HSA-10/B100

In your May 6 letter to Mr. Richard Powers of my staff, you requested the Federal Highway Administration's acceptance of a compression-molded, recycled plastic block for use with steel post w-beam guardrail. Included with your request was a March 19, 2002 report prepared by E-TECH Testing Services, Inc. that summarized pendulum testing conducted on an earlier version of your block that had non-symmetrical ribs. Because this testing resulted in some damage to the sidewalls of the non-symmetrical block and because pendulum testing may not be a reliable surrogate test for a non-solid block, Mr. Powers recommended that your block be redesigned to be fully symmetrical or be crash-tested. On June 28, you submitted the revised final design that is shown as Enclosure 1.

TITLE: GUARDRAIL BLOCKOUT

DR # BLOCK-6-B-14 REV: D DATE: 12-09-01

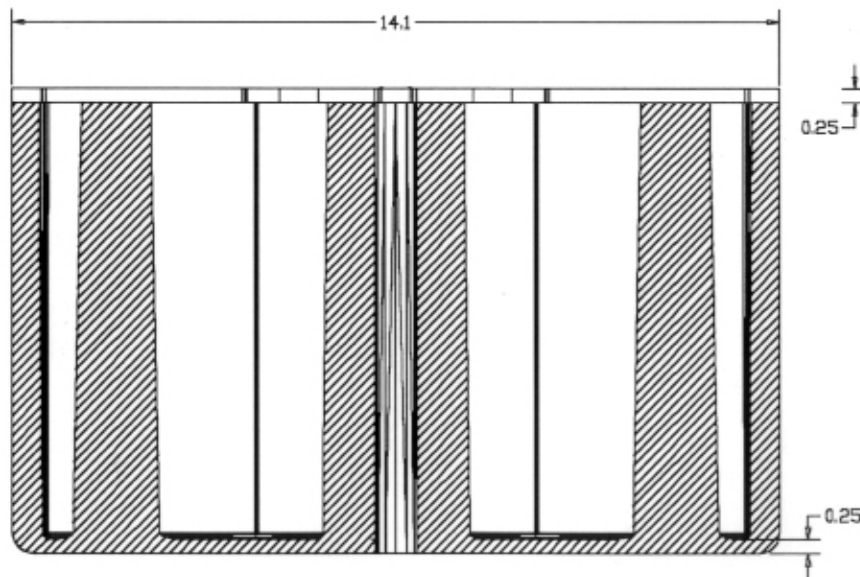
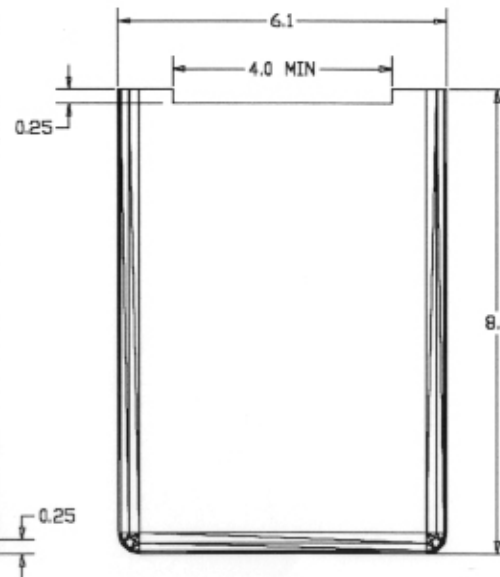
Your 6 inch by 8 inch by 14 inch rectangular block has a sidewall thickness of 3/8 inch, a top and bottom wall thickness of 1/2 inch, and internal web thicknesses of 7/16 inch. The face thickness is 1/4 inch and the field side of the block is open, with a 4-inch wide by 1/4-inch deep routing on the open side. Please note that the recommended minimum width of the routing is 4.3 inches (to accommodate tolerances in the width of the post flange widths). The block is made from 100 percent recycled plastic and filler materials and is 48-52 per cent polyethylene, 40-42 per cent polypropylene, and 10-12 per cent rubber filler.

Based on the results of the original pendulum testing and your subsequent design modifications, the Eco-Composites Blockout, as described above and shown in Enclosure 1, is acceptable for use with steel-post w-beam guardrail on the National Highway System when such use is acceptable to the contracting agency. As with all synthetic guardrail offset blocks, this acceptance is based only the expected crash performance of the Eco-Composite Blockout and is not intended to address its long-term durability. Since it is a proprietary product, the conditions listed in Title 23, Code of Federal Regulations, Section 635.411 apply if the block is used on a Federal-
